Newport Transporter Bridge – ECI Survey Works Report.

The scope of the ECI Survey works are as follows:

CLARIFICATIONS: -

Top Bracing Pin 44 (TBP44)

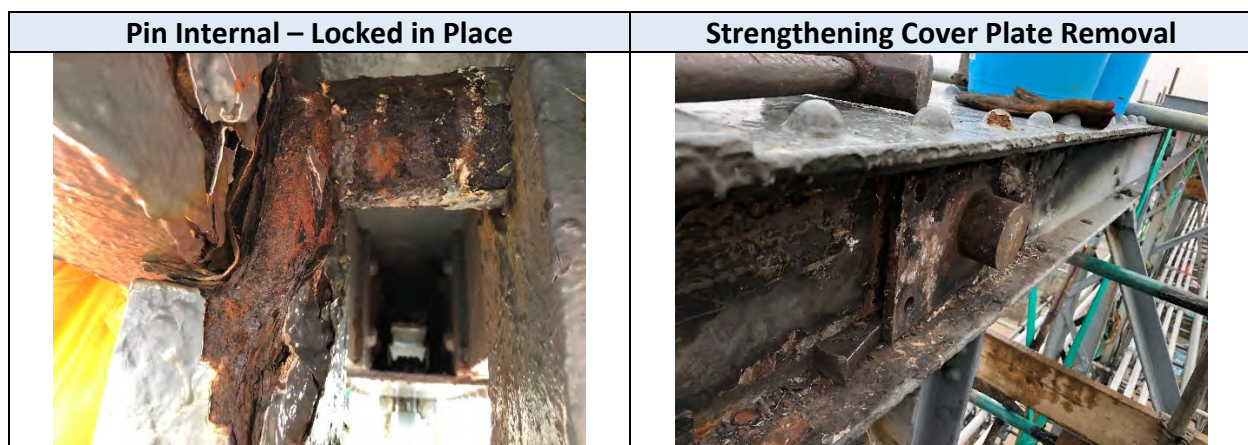
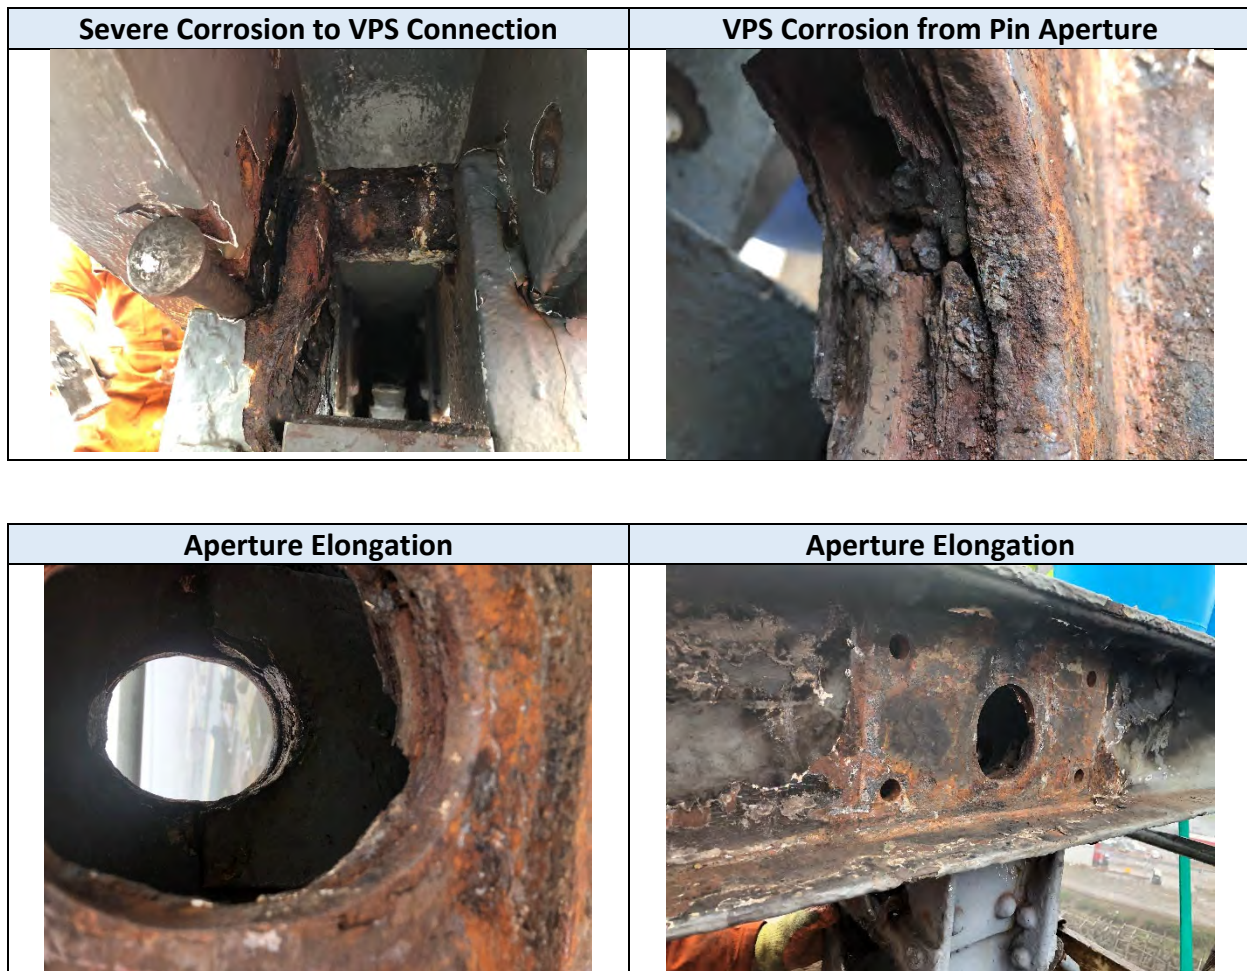
The existing strengthening cover plates affixed to the internal and external faces of the Top Chord Flanges were removed to free up the pin. However, this proved futile as the Pin remained firmly locked in place. *Please Note: The existing bolted connections in each corner of the strengthening plates were all hand loose after removal of the paint, prior to us undertaking any structural works, it is not known how these have all worked loose?*

It became apparent through observation that the Vertical Primary Steelwork (VPS44) was transferring all the weight from the Bottom Chord directly onto the Pin Connection and therefore removal of the pin was unattainable without releasing the applied force.

On removal of the pin it became more apparent that the inside face of the VPS (at the connection to the pin) was heavily corroded/ delaminated and in need of repair. A design will need to be produced to allow such repairs to be undertaken during the core works to ensure a robust connection between the Pin and VPS.

Top Bracing Pin 48 (TBP48)

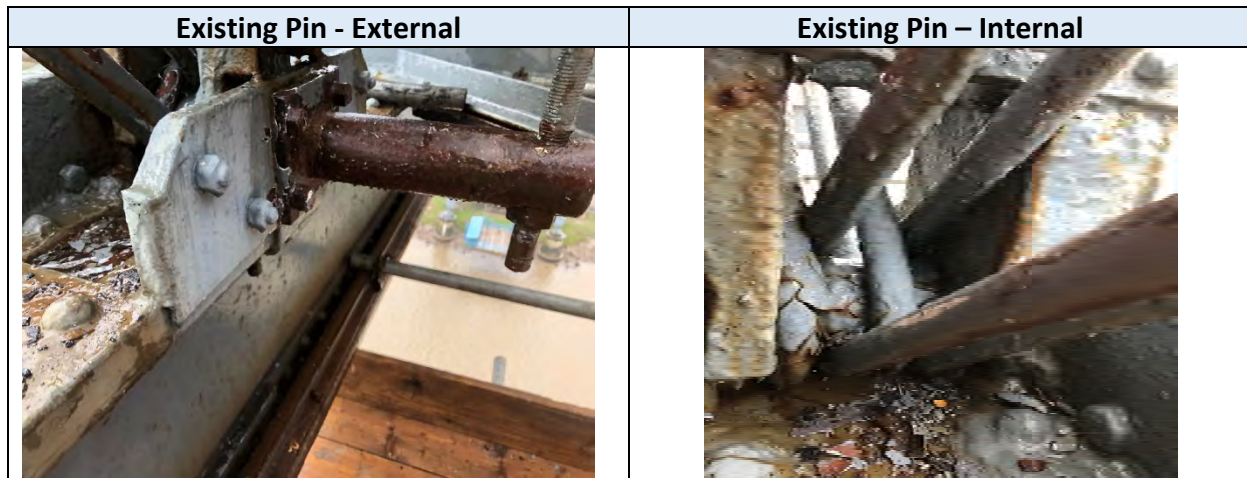
The main difference with this location, was the significant corrosion discovered to the inside face of the Top Chord.

Internal Face of TBP48	Elongation of External Face of TBP48

Item 8. Detailed bearing / anchorage inspection (saddles on top of piers)

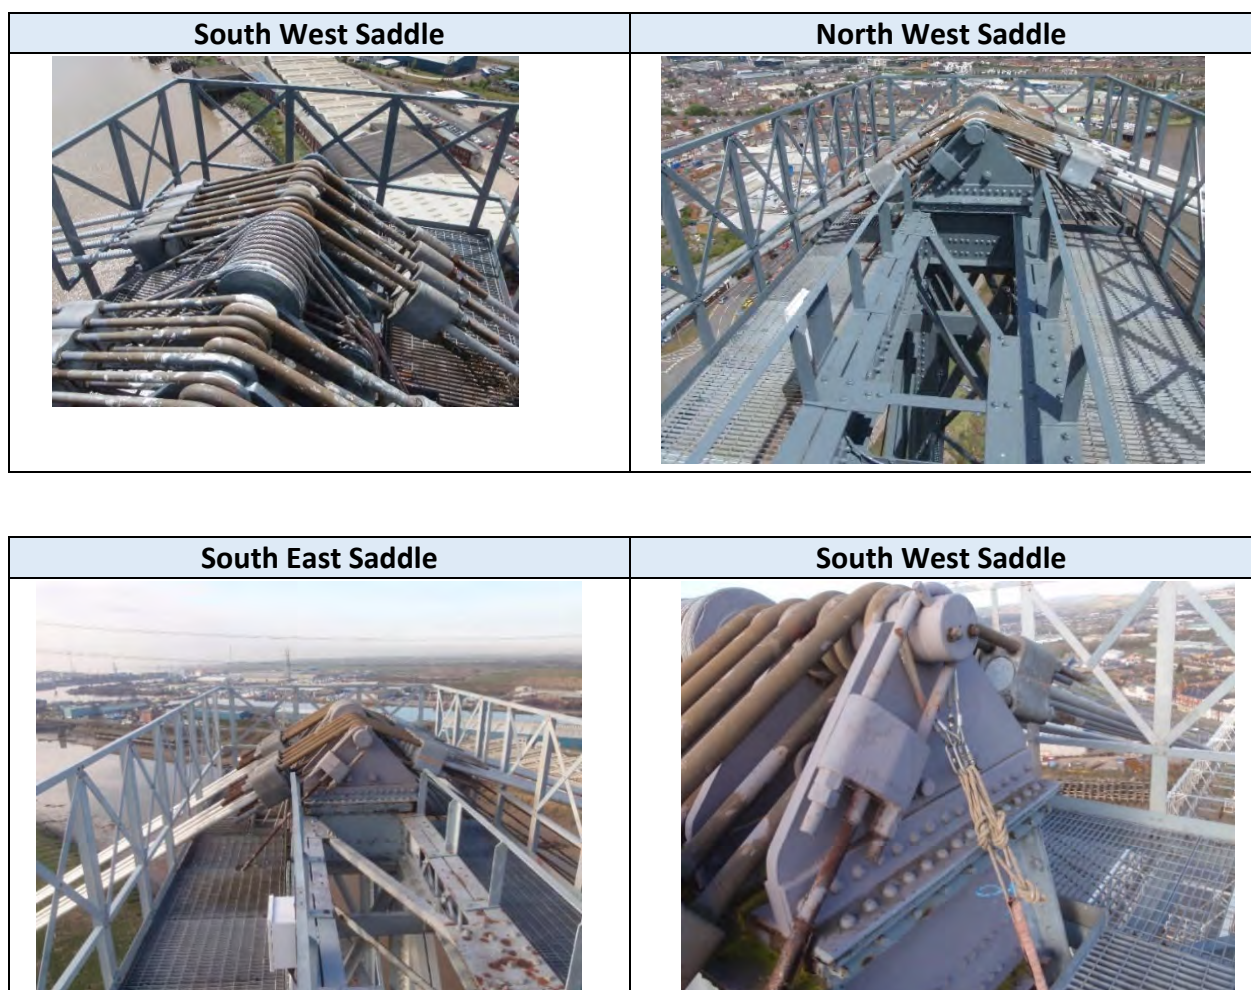
On visual Inspection of the Saddle Anchorages, there does not appear to be any deformation or cracking to the Main Cable U-Bars or the Cable Sockets.

It is difficult to assess the actual saddle and roller arrangements, as these are covered by all the U-Bars, however from the small areas visible under the U-Bars, there does not appear to be any fractures or significant corrosion.
